### Staff Report City of Richmond, Virginia

### Commission of Architectural Review

3. COA-144134-2024	Final Review Meeting Date: 3/26/2024
Applicant/Petitioner	Jennie & Walter Dotts
Project Description	Install a new balustrade.
Project Location	7880/2802 214 316 2712 2718
Address: 2720 East Broad Street	2010
Historic District: St. John's Church	2019 215 22 215 Church 2700 2700 2700 2700 2700 2700 2700 270
High-Level Details:	2801 2801 2801 2801 2801 2801 2801 2801
The applicant proposes to install a new, cast stone balustrade at the primary entrance of a	2718 2610 2610 2610 2700 2718 2700 3413 2813
stuccoed, Italianate building circa 1875.	2014 2016 2016 2017
The balustrade will have the following dimensions: Balusters will be 2' 4 ½" tall.	200 / 213 / St John's - 200 /
Bases will be square 5 ¾". Upper Banister	2702 2702 2704 2704 2704 2704 2705 2704 2705 2704 2705 2706 2706 2706 2706 2707
will be 5 ¾" wide and 4 1/8" thick. Newel post will have an octagonal 8" base.	2708 2719 2719 2719 2719 2719 2719 2719 2719

Figure 1. 2720 East Broad Street. Façade

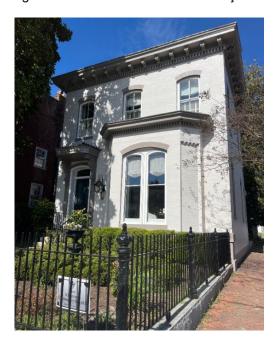
The building has a heavy, wide cornice supported by decorative brackets that wrap its corners and sides. In addition, there is a hood above the front door that features robust brackets. Staff finds that the proportion of the new balustrade is compatible with the building.

Staff finds that the new porch design, while more robust than the existing, is compatible with the overall style of the building and considers it appropriate.
